## Access Compliance Report Public Rights-of-Way (Curb Ramps)

Intersection ID: 50705 Main Street: HARMONIOUS\_ST Cross Street: GENERATIONS\_ST Location: NE

ADA ID: B285A0124DC1 Ramp Type: PerpDiag Initial Pass/Fail: Fail Overall Compliance: No Severity Score: 12.5

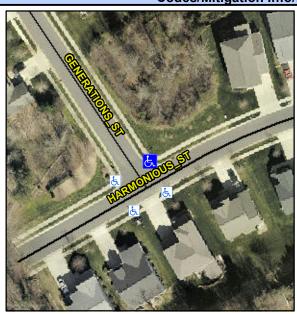
Field Measurements/Component Compliance						
Compliance Description		Data	Comp	liance	Description	Data
N/A	Ramp Length (in)	47.0	No	Ramp	Slope (%)	8.7
Yes	Ramp Width (in)	48.0	Yes	Ramp	XSlope (%)	1.4
N/A	Flare Type LT	N/A	N/A	Flare	Type RT	N/A
N/A	Flare Slope LT (%)	N/A	N/A	Flare	Slope RT (%)	N/A
N/A	Flare Traversable LT?	N/A	N/A	Flare	Traversable RT?	N/A
N/A	Landing Length (in)	N/A	N/A	DWS	Provided?	N/A
N/A	Landing Width (in)	N/A	N/A	DWS	Contrast?	N/A
N/A	Landing Slope (%)	N/A	N/A	DWS	Length (in)	N/A
N/A	Landing X Slope (%)	N/A	N/A	DWS	Full Width?	N/A
N/A	Landing Curb? (Y/N)	N/A	N/A	DWS	Offset (in)	N/A
N/A	Shared Landing?	N/A				
N/A	Gutter Ponding?	N/A	N/A	Gutte	Slope (%)	N/A
N/A	Gutter Lip Ht (in)	N/A	N/A	Gutte	X Slope (%)	N/A
N/A	Painted X Walk1?	No	N/A	Painte	ed X Walk2?	No
	X Walk 1 Direction	To SW		X Wal	k 2 Direction	To SE
N/A	X Walk 1 Width (in)	N/A	N/A	X Wal	k 2 Width (in)	N/A
	X Walk 1 Slope (%)	2.6		X Wal	k 2 Slope (%)	5.8

X Walk 1 X Slope (%)	6.0		X Wal	k 2 X Slope (%)	2.8
N/A	Ramp inside XWalk1?	N/A	N/A	Ramp	inside XWalk2?	N/A
	Road Slope (%)	3.5	N/A	Clear	Space?	N/A
	Road X Slope (%)	5.2	N/A	Clear	Space to XWalk (in)	N/A
N/A	Any Obstructions?	N/A	N/A	Storm	Grate/Utility Hazard?	N/A
	Obstruction Type			Storm	Grate/Utility Type	
		N/A				N/A
			Yes	Surfac	ce Condition? (G/P)	Good
MAN STATE

Remove & Replace Curb Ramp With Two New Directional Ramps or Equivalent.

R304.2.2
